**Re: Concept Plan Application 10\_0193, SIMTA Intermodal Freight Moorebank**

Council's submissions consists of this letter and the attached peer review by Cardno. The following comments are provided to supplement the Peer Review document;

**FIGURE 2**

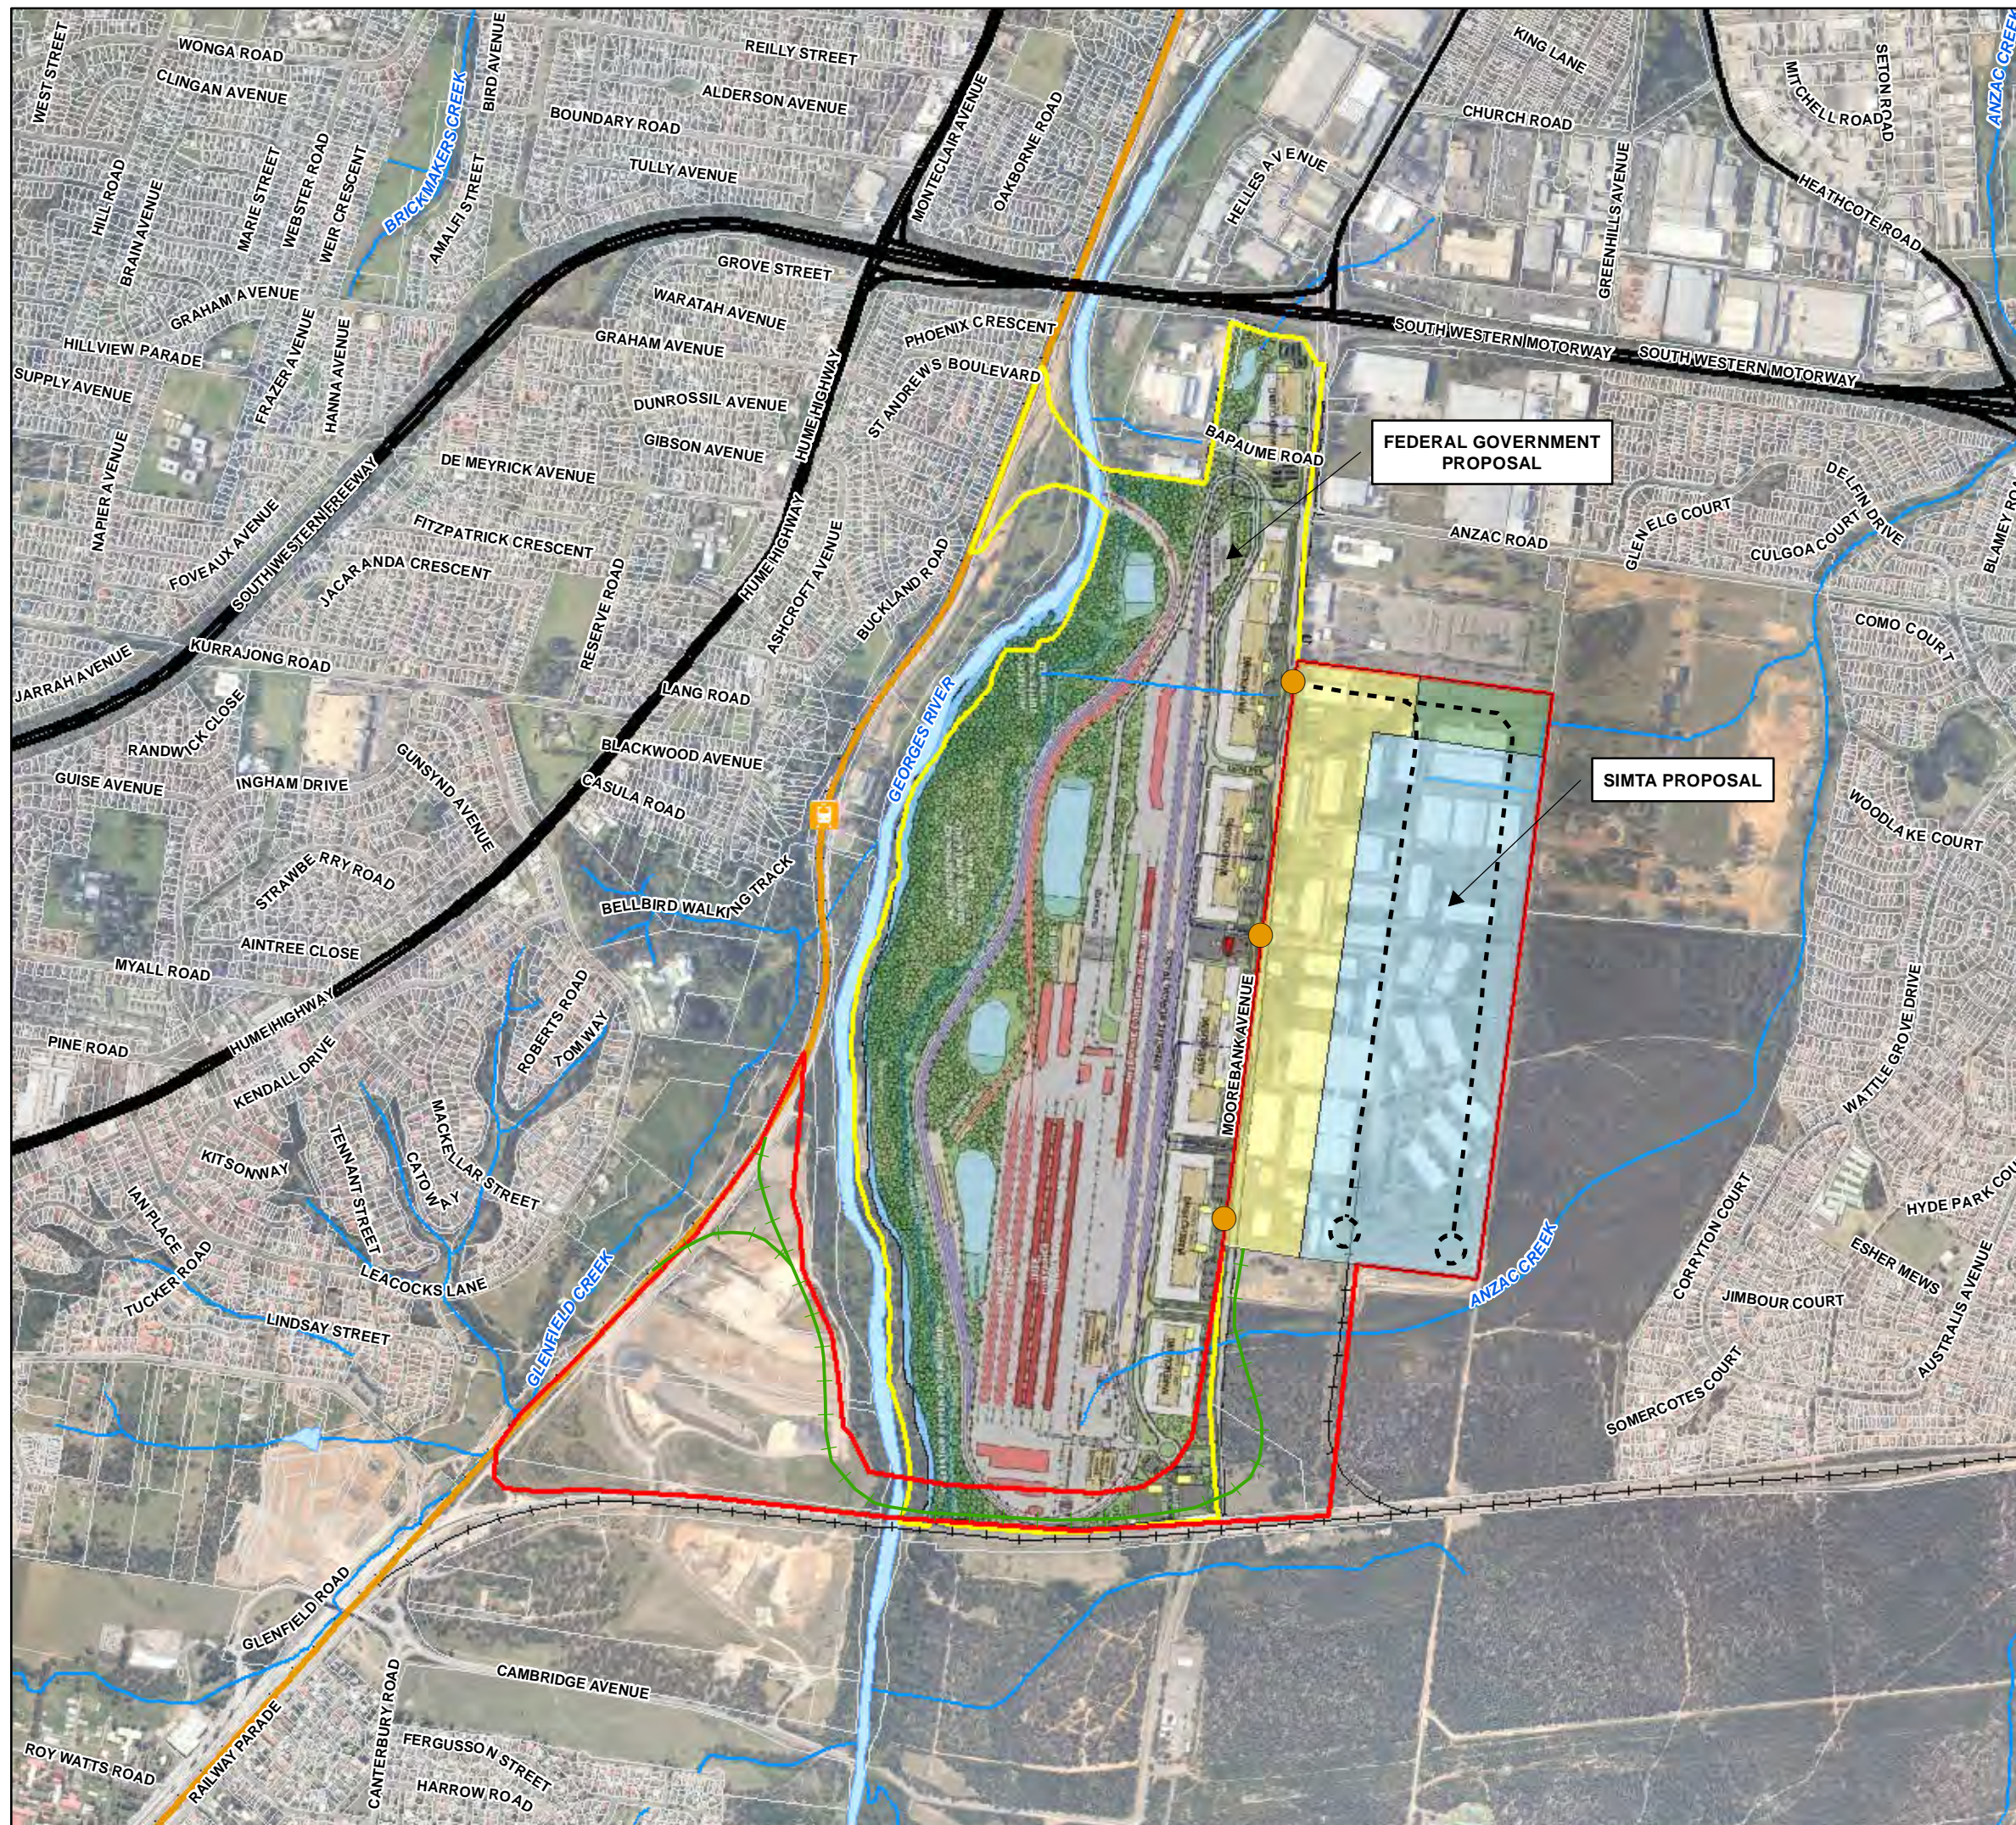
The plan contains no indication of how the proposal will operate and does not include any envelopes of building structures on the site. It is more akin to a Structure Plan, which normally contains less information than a Concept Plan. We therefore do not believe the submitted Concept Plan can be approved for the following reasons:

- The indicative rail spur connecting to the SSFL seems to be located within the Moorebank Project Office site and overlaps the proposed internal road within the adjoining development. There is no information on how this overlapping land uses will be resolved.
- **Figure 2** suggests that there is no co-ordination in the design of the two proposals and it also suggests that there will be two separate rail spurs linking the two sites with the SSFL. This is an inefficient use of the land.

A more detailed Concept Plan is essential to allow an appropriate level of assessment on the proposal. The applicant must provide an appropriate Concept Plan and it must include:

- Concept design of the rail spur outside the site boundary, including appropriate curvature and correct location that does not overlap on the adjoining Defence land.

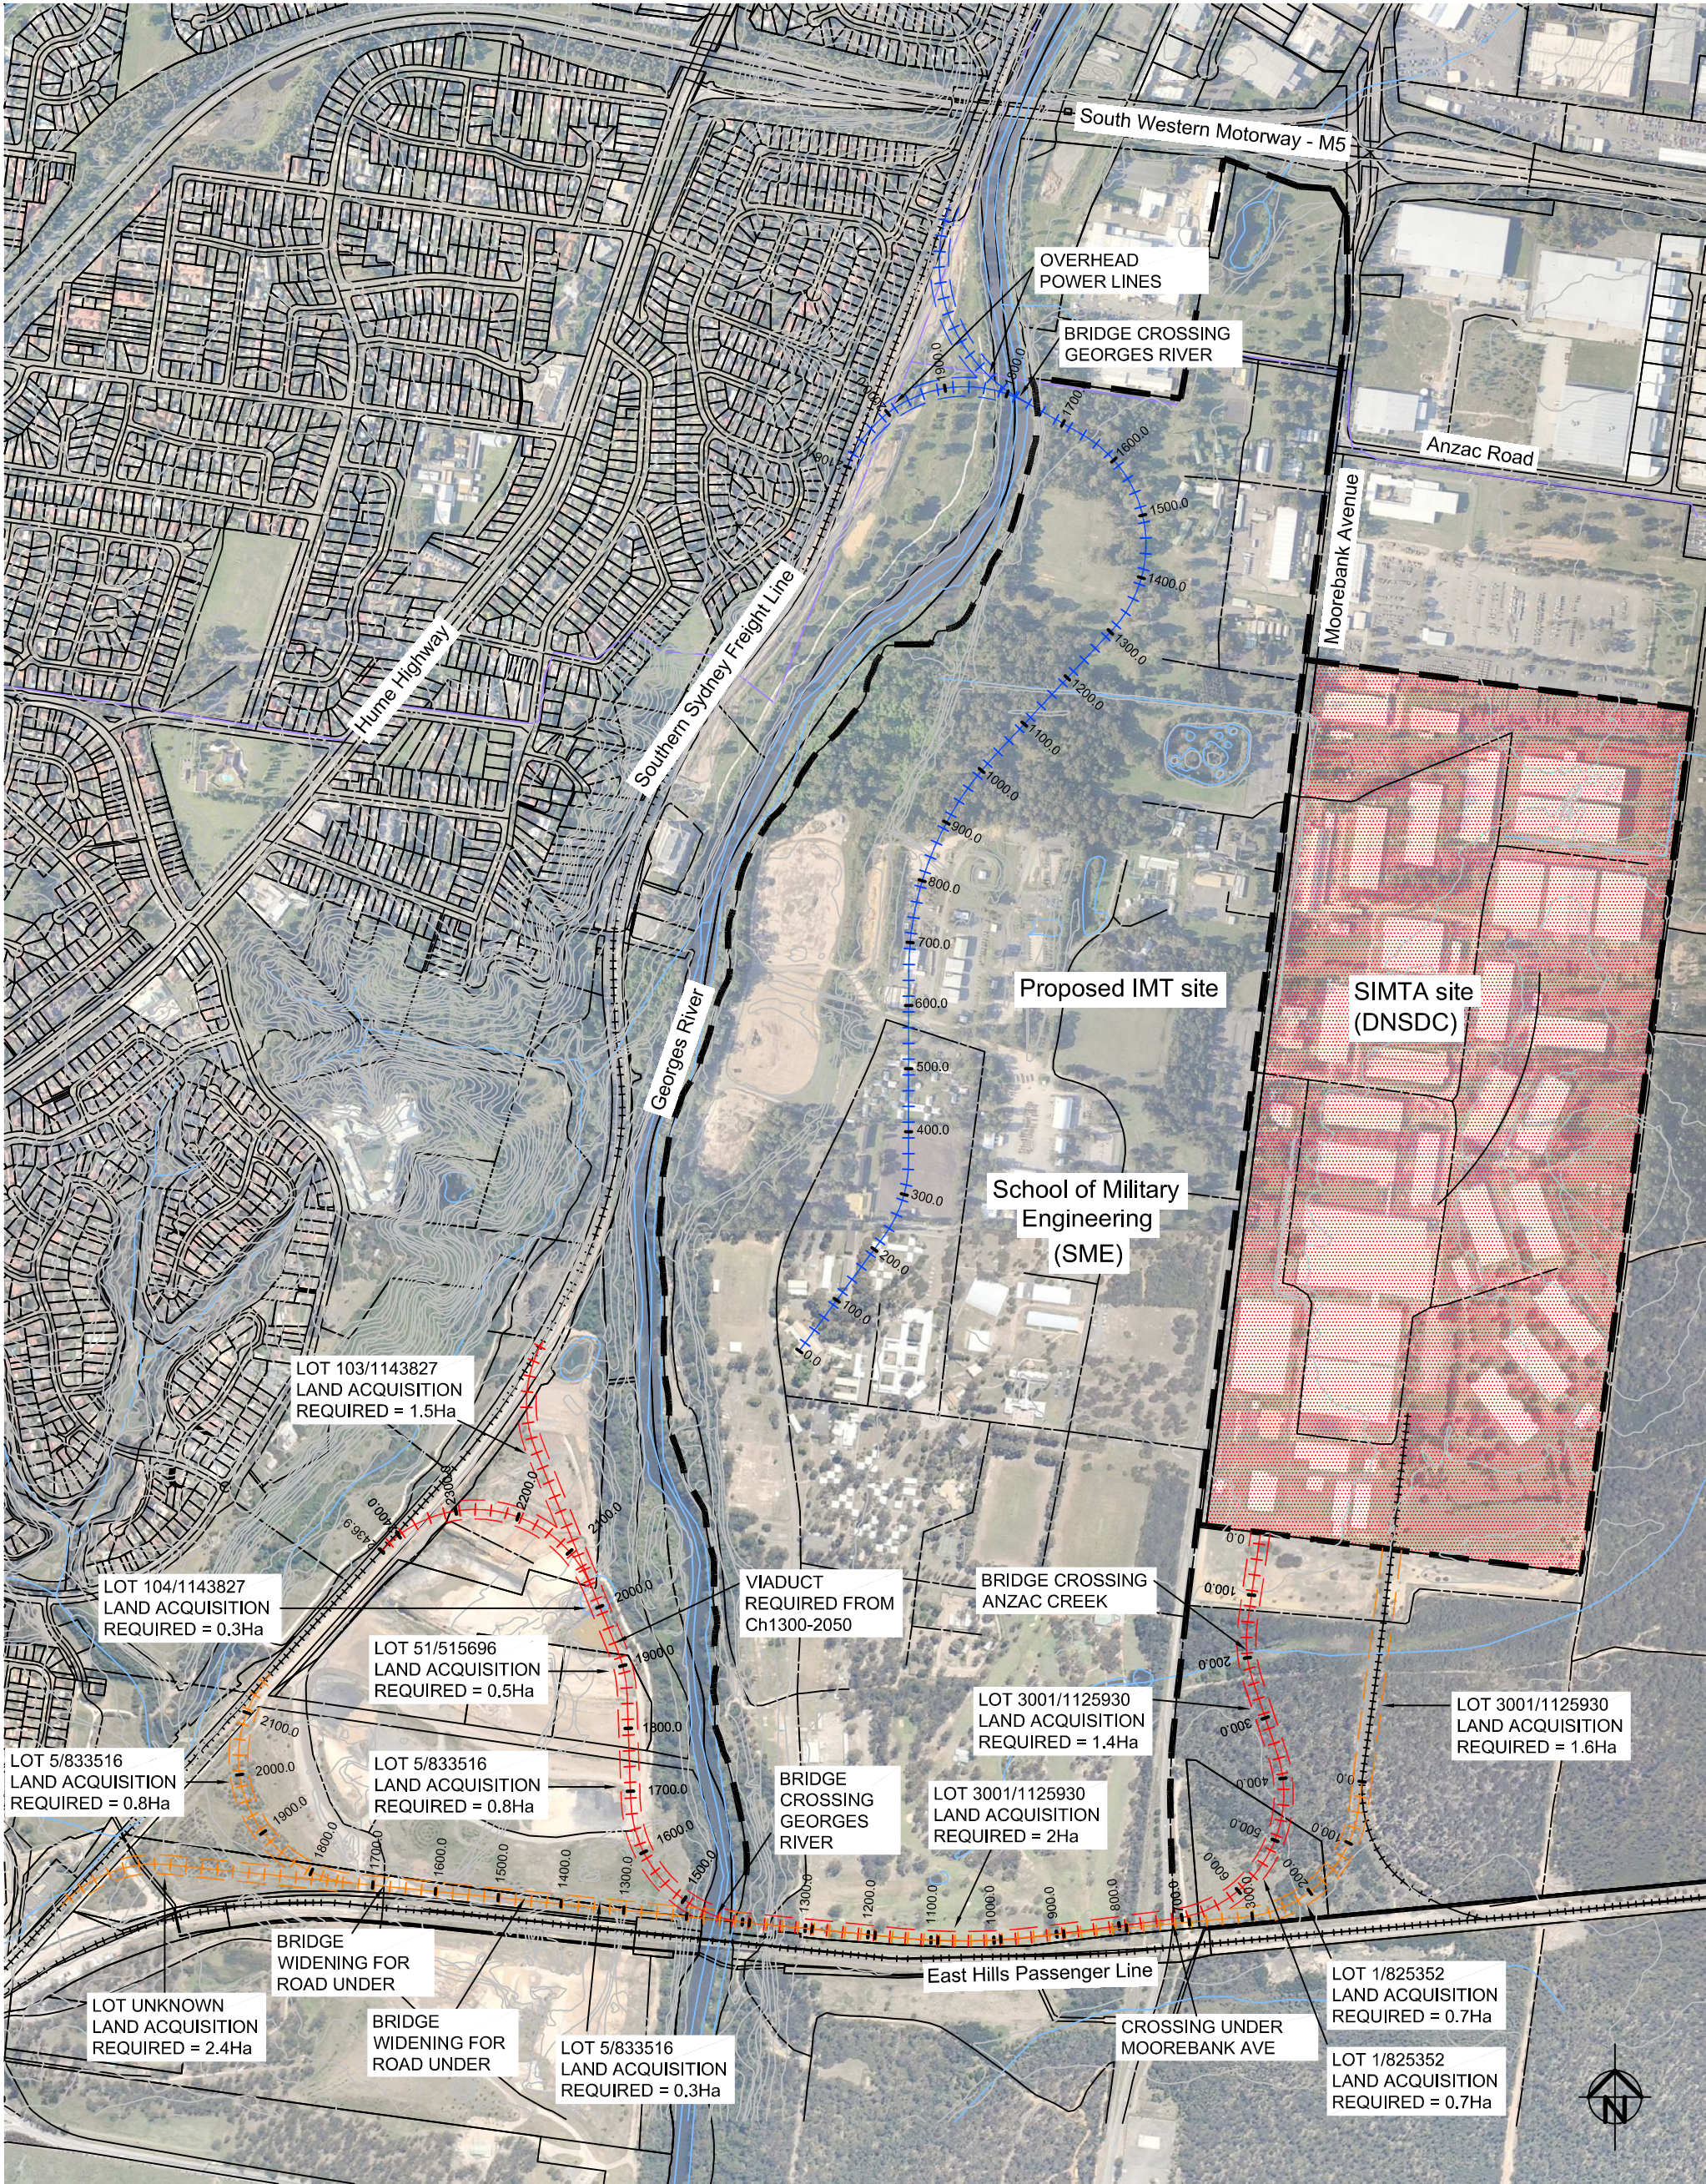
- Commitment from ARTC is also critical to give certainty to the Government and the affected community about the extent and timing of the works.
- Our assessment based on the limited information on the rail link from the site to SSFL (**Figure 3**) suggested that the proposed rail spur includes unnecessary curves that have not been tested geometrically. A substantial amount of investigations, including flooding, geotechnical, ecology, bushfire and site contamination need to be undertaken, even on a preliminary level, on the rail spur land to confirm the capability of the site to support the development.

- The proposed rail spur to the south of the site contains threatened species that are listed in the Commonwealth Environmental Protection and Biodiversity Conservation (EPBC) Act and this rail spur is creating the most significant environmental impacts out of all of the structures proposed in this application. Limiting the size of this rail spur will assist in alleviating the environmental impacts of the proposal. Straightening the alignment as shown in **Figure 3** can create a safer and more

- Regardless of which rail spur option, an approximate area of  $10\text{ha}$  land acquisition is required and there is no evidence in the submitted documents suggesting that this issue has been resolved.

Because the railway spur and the SSFL expansionary infrastructure are crucial parts of the proposal, the location, concept designs, land owners commitment and financial arrangement of these works must be addressed in the application to allow appropriate assessment of the full extent of the proposal. Without this information, the determination of this application is premature.

- Concept design of all expansionary infrastructure to the SSFL required to provide the required capacity sought by SIMTA.
- Commitments from the ARTC to the expansionary infrastructure and indication of the funding arrangement, timing of the delivery and the scope of works.

**Figure 8 - Road Upgrades Proposed by SIMTA**

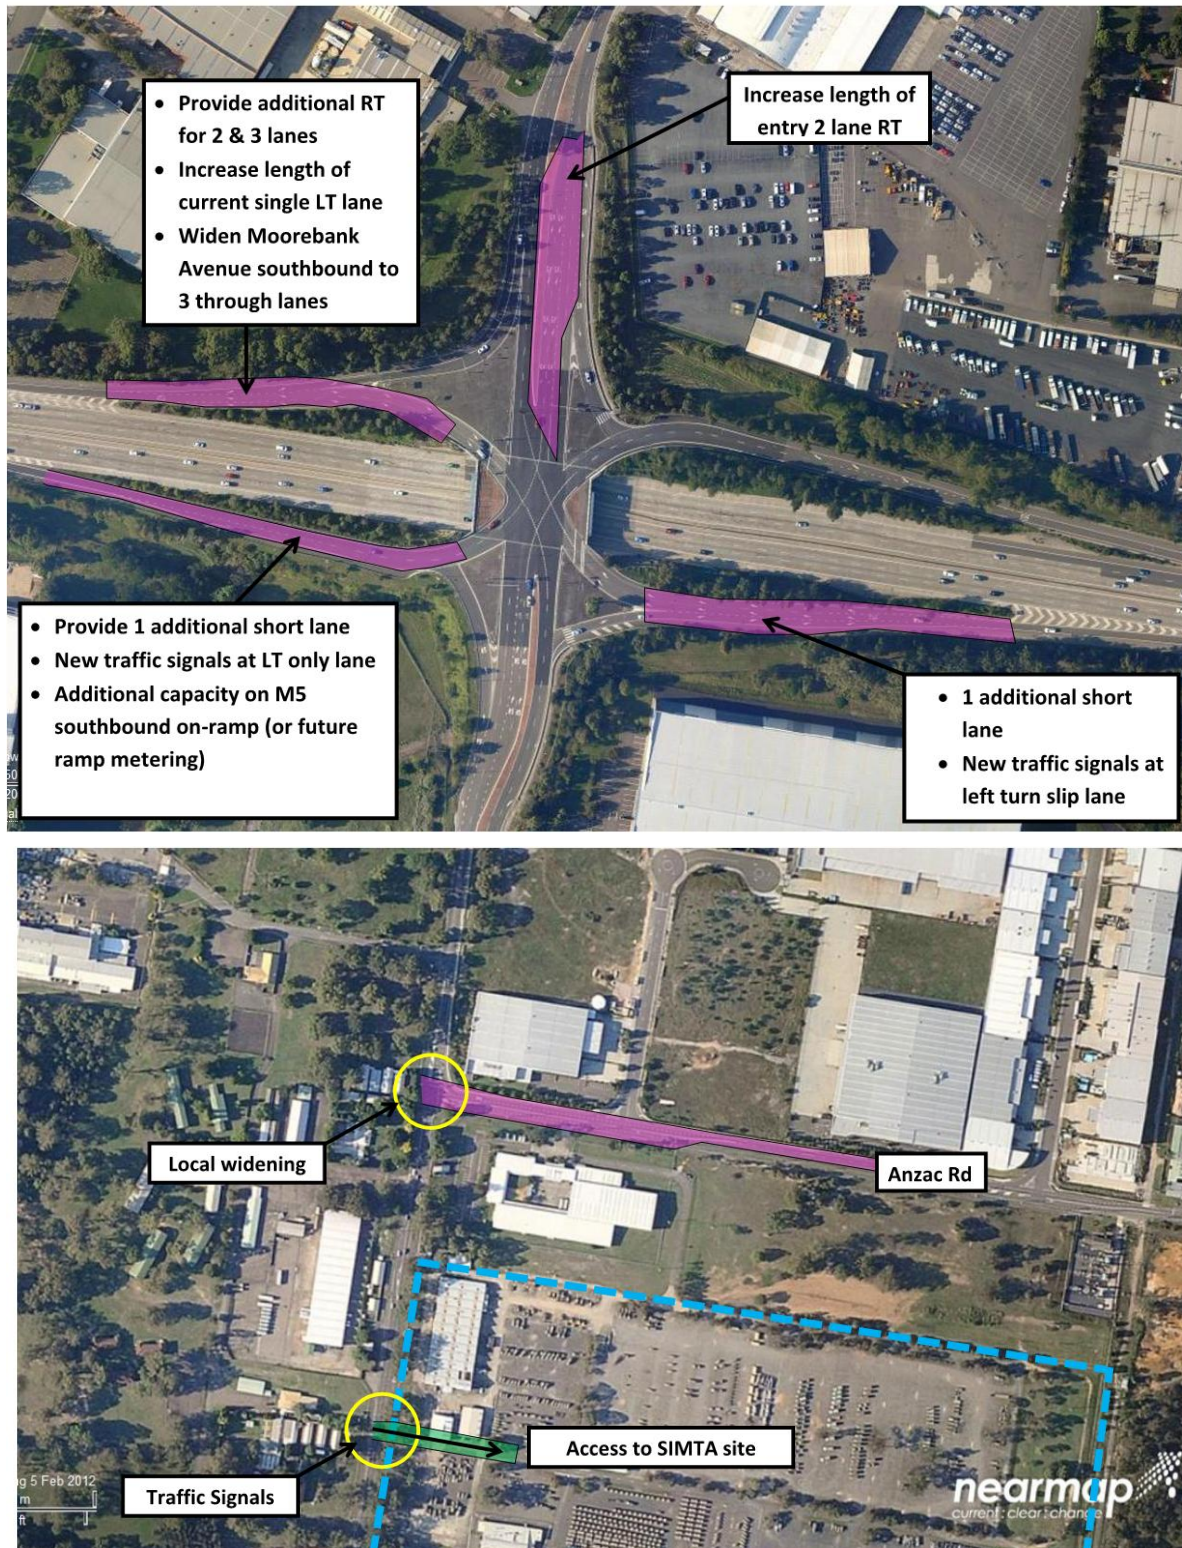
- The increase in truck traffic in the Liverpool LGA will have an impact on Council's Regional and Local roads with respect to the traffic capacity of these roads and the structural capacity of the road pavements to carry the additional truck loads. The EA report does not provide any traffic data to assess the damage the increase in truck traffic will have on their roads

- The charts in **Annex A** graphically show the results from the SIMTA's reports of the future 2031 traffic models at 13 locations around the SIMTA site. The plans show those intersections operating at Levels of Service less than LoS F and at LoS F; Level of Service F means that the section of road or intersection has failed and as such it is at an unsatisfactory level of service with excessive queuing. LoS F was chosen to highlight the seriousness of the section of road or intersection to accommodate additional traffic and therefore show that further detailed investigations would be required to determine what measures would be required to allow these sections of road or intersections to operate at a higher level of service such as at LoS D or E in the peak hours.
